<p>OS-299 (5-21)</p>  <p>pennsylvania DEPARTMENT OF TRANSPORTATION www.penndot.gov</p>	<p>TRANSMITTAL LETTER</p>	<p>PUBLICATION: Publication 219M</p> <hr/> <p>DATE: 10/7/2024</p>
<p>SUBJECT: Standards for Bridge Construction September 2016 Edition Change 7</p>		
<p>INFORMATION AND SPECIAL INSTRUCTIONS:</p> <p>Incorporate the attached revisions into the September 2016 Edition of Publication 219M.</p> <p>These revisions provide details for the connection of W-Beam Guide Rail (Type 31-S) to bridge barriers on the trailing end of bridges on divided highways and one-way roadways.</p> <p>These standards may be used immediately and can be adopted as soon as practical on all new and existing projects without affecting letting schedules and in conjunction with the current Publication 408 Specifications. Projects let after April 11, 2025 must incorporate these new standards.</p> <p>A description of the changes made to the 2016 Edition since Change 6 on March 27, 2024 are listed in the attached multi-sheet table. On the standards, light red highlighting indicates Change 7 revisions to details and notes.</p> <p>Comments or questions concerning this Publication may be directed to the Bureau of

SHEET 8 OF 13
BC-709M

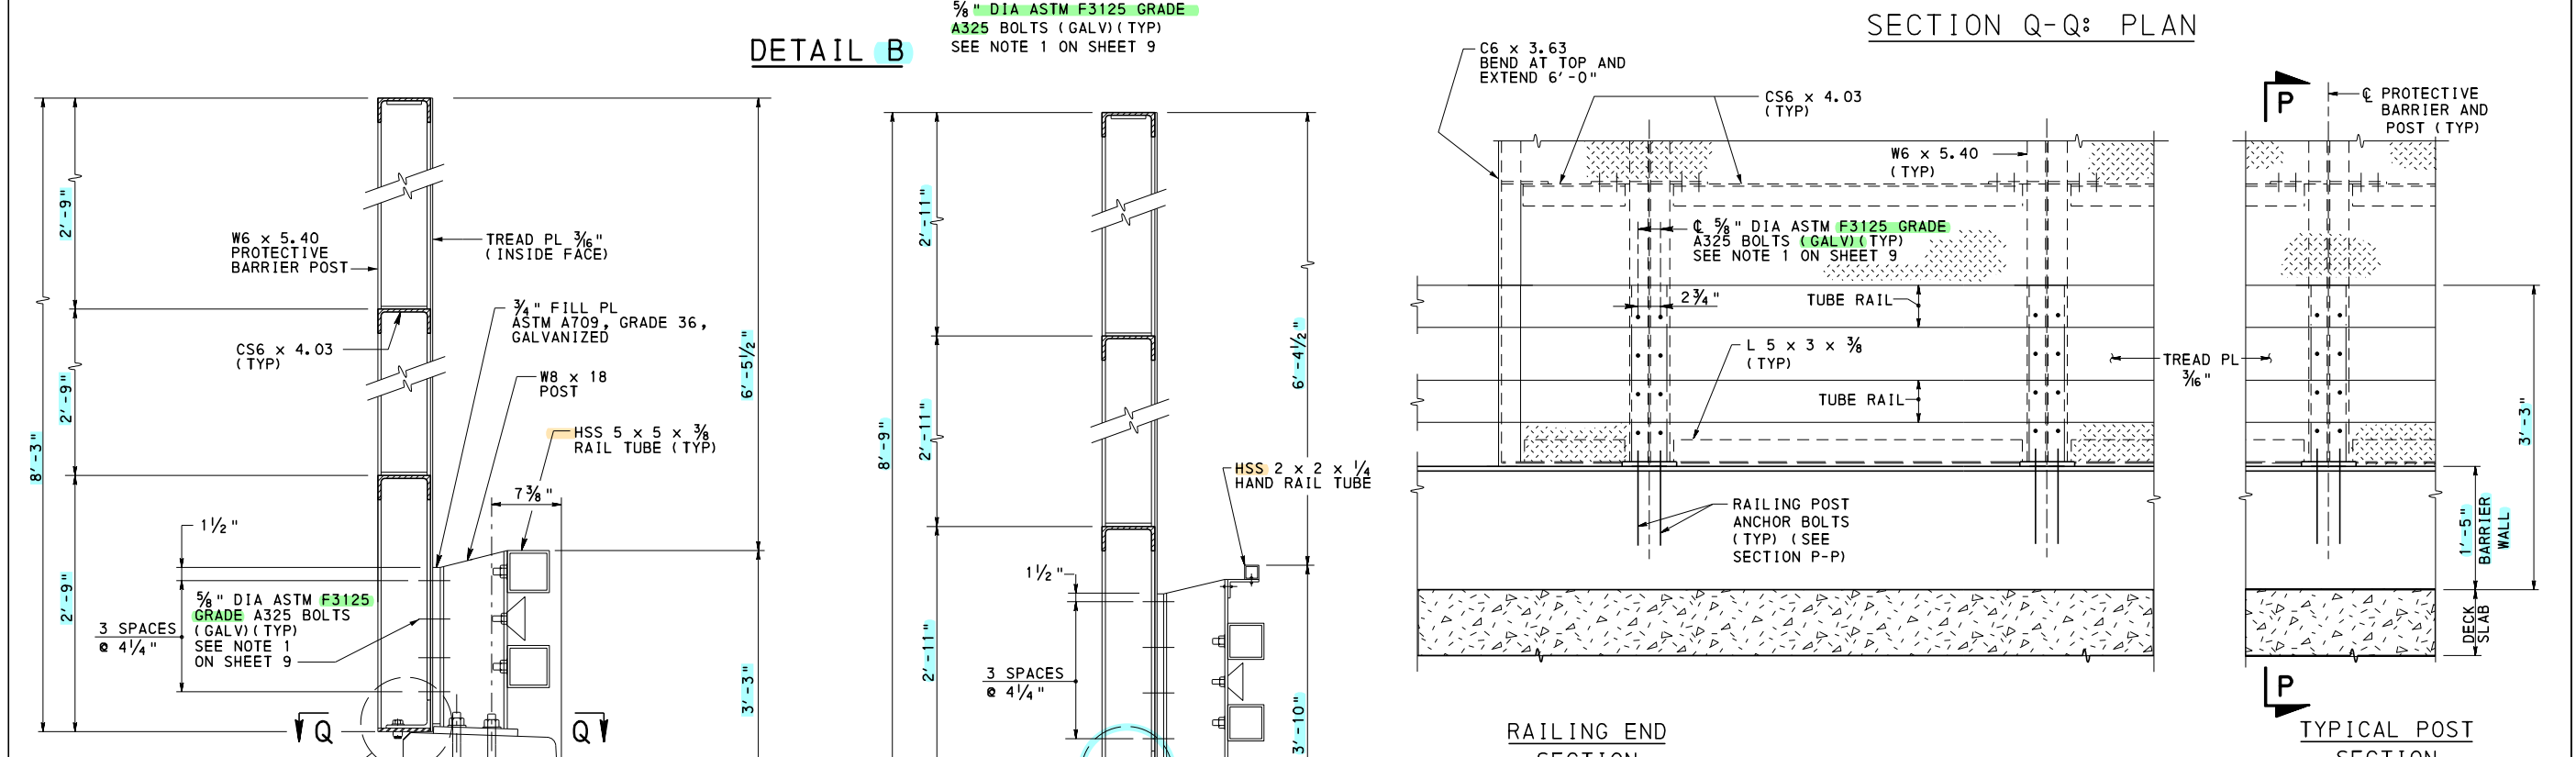
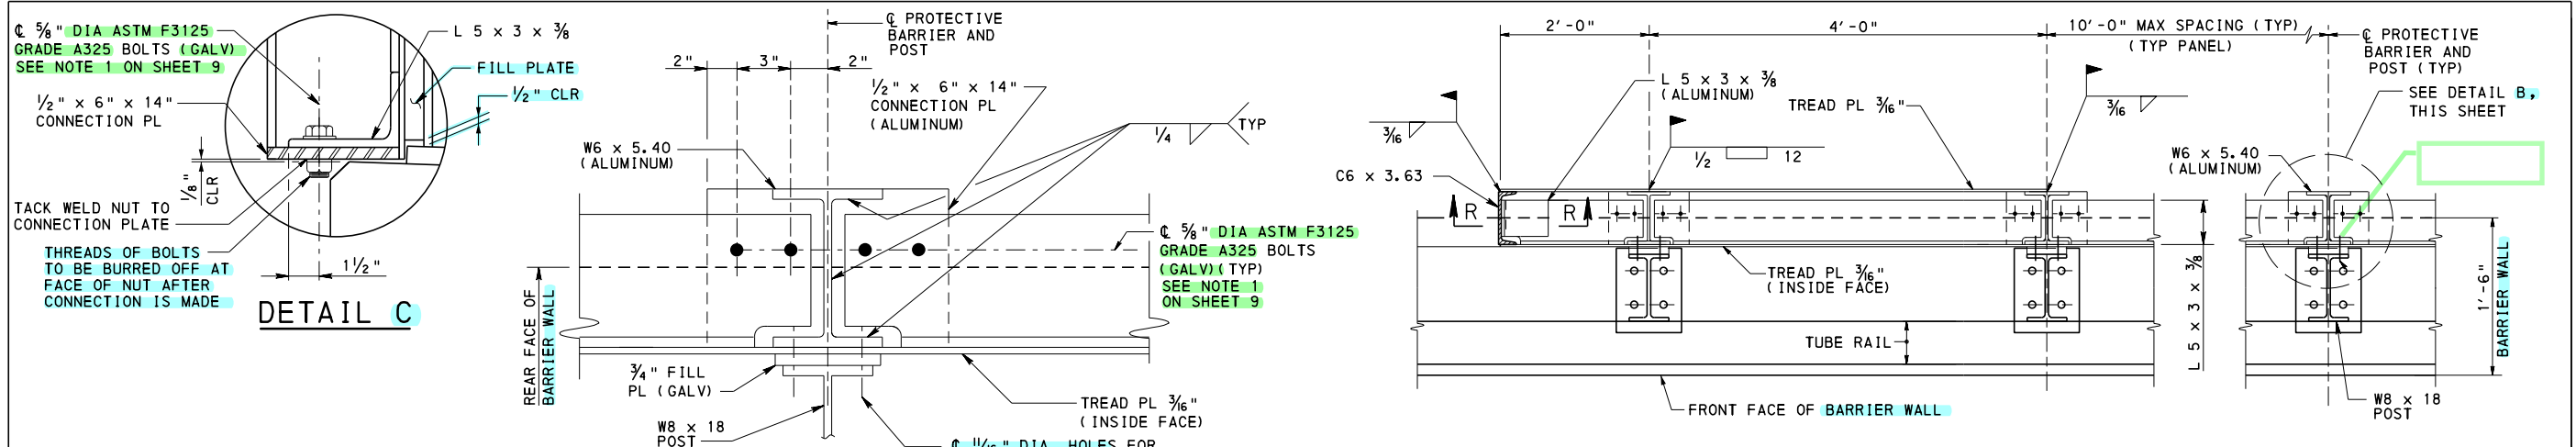
3 of 13 (formerly 3 of 12)	<p>PA TYPE 10M BRIDGE BARRIER TYPICAL SIDEWALK:</p> <ul style="list-style-type: none"> Added “WITH THRIE-BEAM CONNECTION” to detail name. <p>PLAN VIEW:</p> <ul style="list-style-type: none"> Removed “TOP” from the callout for “HSS 5x5x3/8” RAIL TUBE”. Added bottom rail to detail. Added “(TOP RAIL)” to the callout for the “BEND POINT”. <p>ELEVATION VIEW:</p> <ul style="list-style-type: none"> Added callout for “CL THRIE-BEAM RAIL”. Added 1’-9” and 1 3/4" dimensions. Added 3/4" hole, callout and 10 3/4" dimension for the hole in the bottom rail.
	4 of 13 (formerly 4 of 12)	<p>PA TYPE 10M BRIDGE BARRIER ALTERNATE SIDEWALK:</p> <ul style="list-style-type: none"> Added “WITH THRIE-BEAM CONNECTION” to detail name. <p>PLAN VIEW:</p> <ul style="list-style-type: none"> Removed “TOP” from the callout for “HSS 5x5x3/8” RAIL TUBE”. Added bottom rail to detail. Added callout “(TOP RAIL)” to the callout for the “BEND POINT”. <p>ELEVATION VIEW:</p> <ul style="list-style-type: none"> Added callout for “CL THRIE-BEAM RAIL”. Added 1’-9” and 1 3/4" dimensions. Added 3/4" hole, callout and 10 3/4" dimension for the hole in the bottom rail.

ALUMINUM PROTECTIVE BARRIER AT PA TYPE 10M BRIDGE BARRIER

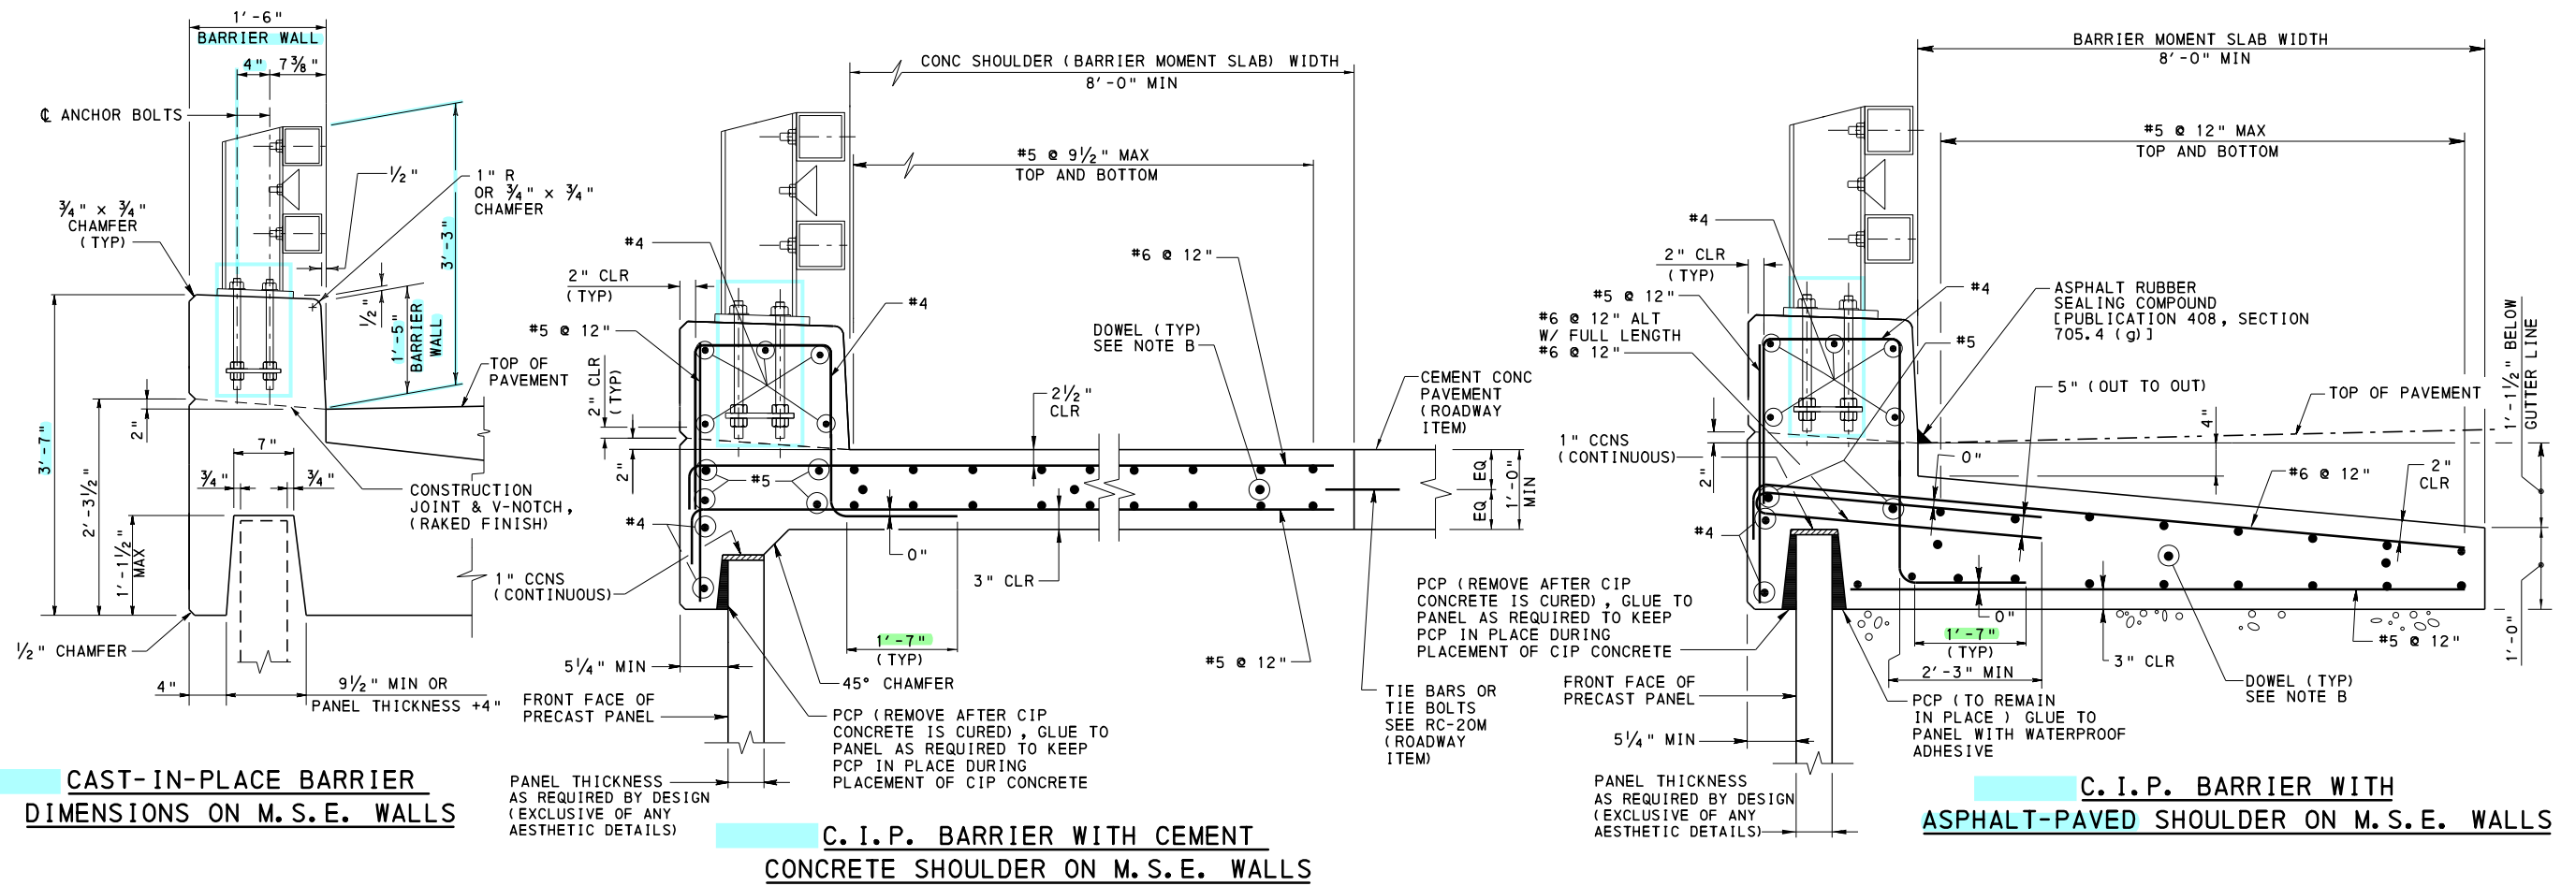
9 of 12	<p>TITLE BLOCK:</p> <ul style="list-style-type: none"> Revised "MISCELLANEOUS DETAILS" to "ALUMINUM PROTECTIVE BARRIER DETAILS". <p>POST AND BASE PLATE:</p> <ul style="list-style-type: none"> Revised 2 1/2" to 2 7/8". Revised 4 3/8" to 4". Revised "SHEET 1" to "SHEET 2". <p>POST MOUNTING ON GRADE:</p> <ul style="list-style-type: none"> Revised "CONCRETE CURB" to "BARRIER WALL".
